Subject: **FLASHING PICTURE OR IRREGULAR  
 WHITE BALANCE**

Model: **BVM-8044QD, PVM-5041Q, PVM-8040  
 PVM-8041Q, PVM-8043MD, PVM-8044Q**

**Figure 1**

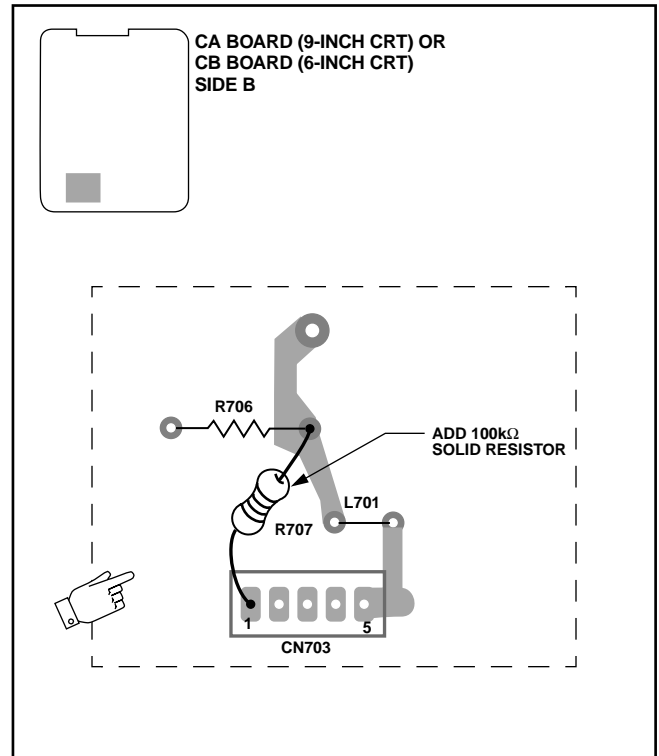
In some units, the picture may flash or white balance may become irregular. If this occurs, perform the following procedure.

**CA Board (9-inch CRT) or CB Board (6-inch CRT)  
 Side B (See Figure 1.)**

1. Replace CRT.
2. Solder new 100kΩ solid resistor as shown.
